Review Date: **MARCH 1, 2024**

Permit No.: **PZ23-0008**

Project Name: **SUBMITTAL NO. 4 REVIEW – REVISION 1**
PROPOSED COMMERCIAL DEVELOPMENT
METAL ROLL FORMING COMMERCIAL FACILITY
25870-000-000: 909 WEST STREET, PARKER, FLORIDA 32404
25869-000-000: 4623 EAST 2ND STREET, PARKER, FLORIDA 32404
25838-000-000: 4610 EAST HIGHWAY 98 BUSINESS

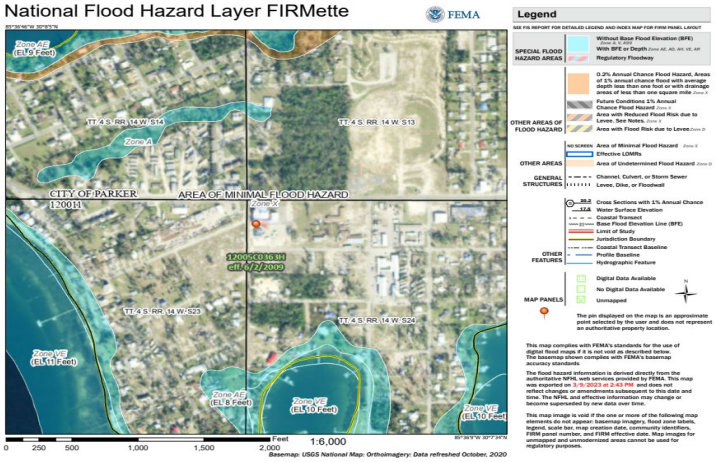
CITY COMMENT 01/26/24: A revised Site Plan was submitted on 01/23/24 which included an updated Site Data table. With the information provided, the following lot coverage has been calculated:

Impervious Surface	Size in SF
Building	28,000
Pavement/Parking	12,787
Sidewalks	1,128
Heavy-Duty Asphalt	7,297
Gravel	1,484
Stormwater Ponds	5,136
Total	**55,832**

Lot Coverage = Impervious Surfaces (SF)/Lot Area (SF)
Lot Coverage = 55,832 SF/125,017 SF = 44.65%

It should be noted that Lot Coverage is not denoted on the plan set. As a conditional approval, please add the Lot Coverage of 44.65% under the Site Data Table in the final signed and sealed plan set.

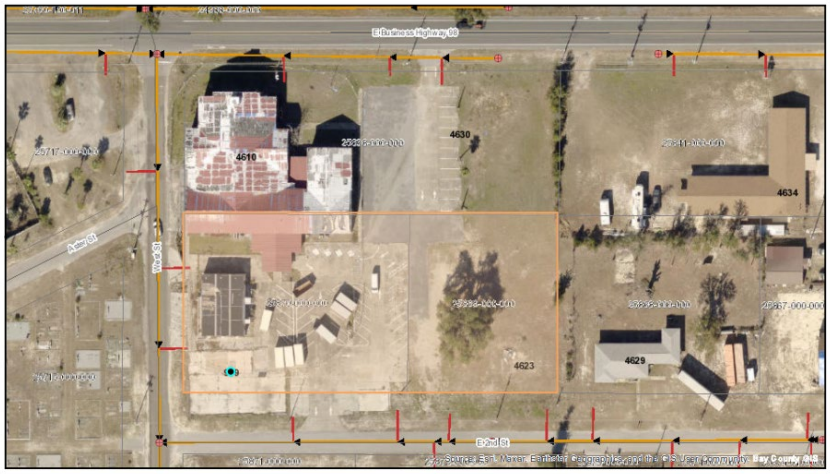
17. Impervious Surface Ratio (ISR)	**APPROVED 01/26/24:** **CITY COMMENT 8/15/23**: As referenced in Article 4-5.4.3.f – General Commercial – Impervious Surface Ratio is indicated as 0.7 ISR is calculated according to the lot area and impervious surfaces on the parcel. Applicant is required to provide a Site Data Table which includes impervious structures and will have enough information to show how the applicant came to 0.7 ISR per the plans. This should include a breakdown of the square footage of the impervious surfaces. It should also be noted that the Site/Zoning Information data does not reflect the three parcels being constructed on. According to the Survey, these three parcels are a combined 2.87 acres. The information provided under the Site/Zoning Information on SHEET 4 of 10 indicates a site area of 1.47 acres, which, it is assumed that this was used to calculate lot coverage and ISR. Please correct the Site Area and ensure all calculations pertaining to Lot Coverage and ISR are correct. **APPLICANT RESPONSE 10/25/23:** The ISR has been included on the site data table on Sheet 4. **CITY COMMENT 11/10/23**: A revised Site Plan was submitted on 10/30/23 which included the development of the upper parcel (corner West Street and Business U.S. Highway 98) and lower parcel (north corner of West Street and East 2nd Street) and an updated Site Data table. With the information provided, the following lot coverage has been calculated: **Impervious Surface** / **Size in SF** Building: 28,000 Pavement/Parking: 12,787 Sidewalks: 1,128 Heavy-Duty Asphalt: 7,297 Gravel: 1,484 **Total: 50,696** The number calculated from the Data provided on the Site Data table differs from what Applicant has provided as the total. Applicant indicated that total impervious structures is 44,000 SF. Whereas, the total impervious when calculated from the Site Data Table is 50,696 SF. Please recalculate and revise Site Data table accordingly.

ISR does <u>not</u> include stormwater ponds. ISR = Total Impervious (minus SW Ponds)/Total Lot Area ISR = 50,696 SF/125,017 SF = 0.41 Applicant indicated an ISR of 0.35 which is assumed to be because of the total impervious area discrepancy stated above. Please recalculate and revise the ISR using 50,696 SF of impervious structures. **CITY COMMENT 01/26/24:** A revised Site Plan was submitted on 01/23/24 which included an updated Site/Rezoning Information section. With the information provided, the following ISR was recalculated by the Applicant: **Impervious Surface** / **Size in SF** Building — 28,000 Pavement/Parking — 12,787 Sidewalks — 1,128 Heavy-Duty Asphalt — 7,297 Gravel — 1,484 **Total** — **50,696** ISR = Total Impervious (minus SW Ponds)/Total Lot Area ISR = 50,696 SF/125,017 SF = 0.41 ***This comment has been addressed.***
